SERVICE BULLETIN

ELECTRICAL POWER — BATTERY
BATTERY CELL CAN DEVELOP A SHORT CIRCUIT
MARATHON DOCUMENT NUMBER 32364-01

BA36-24-01

Figure 1
BA36-01 Battery Disassembly/Assembly

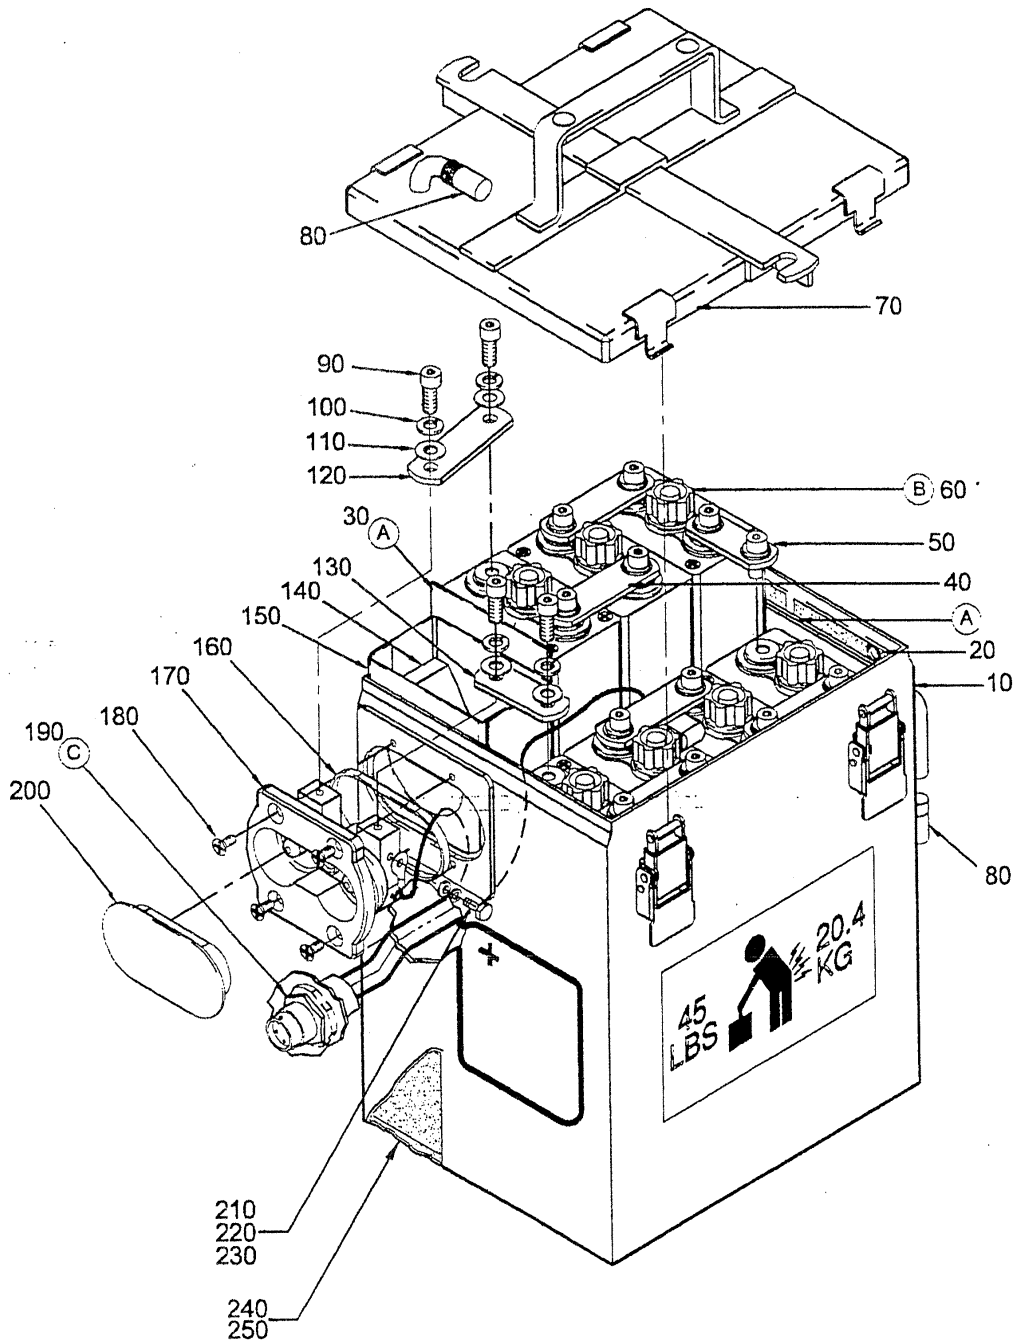
- (d) Remove the screws (90), washers (100), and washers (110) to remove the inter-cell connectors (40 and 50) and the end-cell connectors (120 and 130).

- (e) Use the vent cap wrench to loosen, but don't remove, the vent caps (65) of the cells to be removed.
- (f) Use the cell puller to remove the cell (60). Always tighten the cell puller to the cells and use an even, straight-up pull to remove the cells from the battery. If the cells are difficult to remove, use a syringe to put about 5 cc of de-ionized water along side each cell as a lubricant.

- (g) Pull and remove cells one and two from the battery, which gives access to the temperature sensor assembly (190) plate. Move the plate away from cell three and continue to remove the cells.

- (i) Remove and retain (for assembly) the loose shims (30) from the battery.

Replace the seven old 75M³ 120 Cells (Marathon P/N 32495-001) with the seven new 75M³ 120 MOD A Cells (Marathon P/N 32495-002). Use the Assembly Procedure that follows to install the new cells and to re-assemble the battery.

- (c) Install the inter-cell connectors (40 and 50) and the end-cell connectors (120 and 130) with washers (110), washers (100), and screws (90). The screws (90) must only be finger-tight at this step in the procedure.

- (d) Tighten the screws (90) in the sequence that follows:
 - (1) Always tighten the screws (90) that fasten the inter-cell connectors (40 and 50) to the cell (60) terminals in a sequence that starts with cell number one and ends with cell number seven. Tighten every screw (90) on every inter-cell connector (40 and 50) to a torque value of 100 – 125 lb-in.

- (2) Tighten the screws (90) that fasten the end-cell connectors (120 and 130) to the negative and positive terminals of the receptacle assembly (170) to a torque value of 100 – 125 lb-in.

Figure 2
Detail View

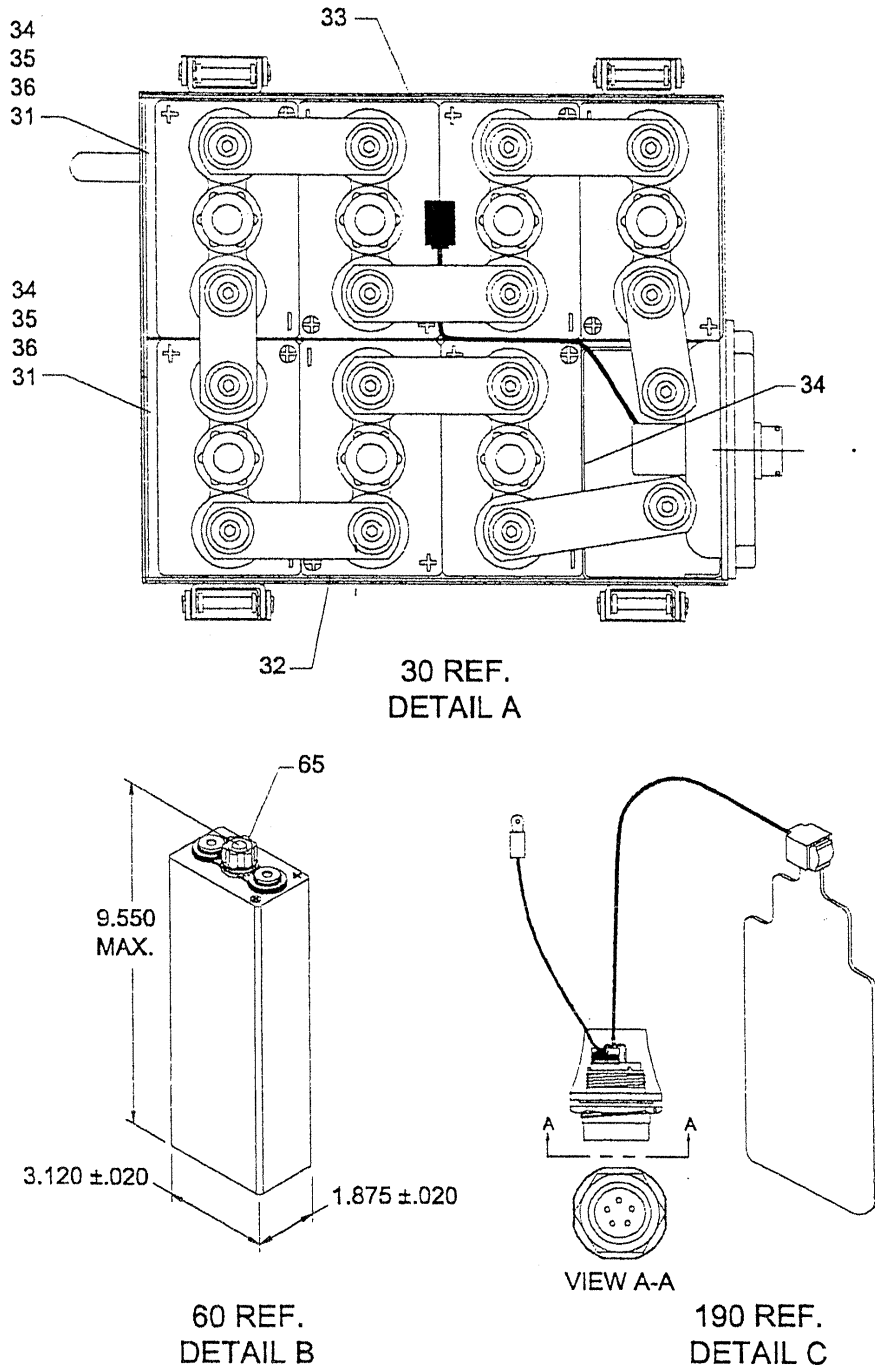
- (1) Start the cell (60) installation with cell number four. Install the plate of temperature sensor assembly (190) between cell (60) number two and number three. Position the wires from the temperature sensor assembly (190) as shown in Figure 2.

- (2) Install the shims (30) as you insert each cell (60) into the marked can assembly (10). Position the shims (30) for each cell (60) as shown in Figure 2.
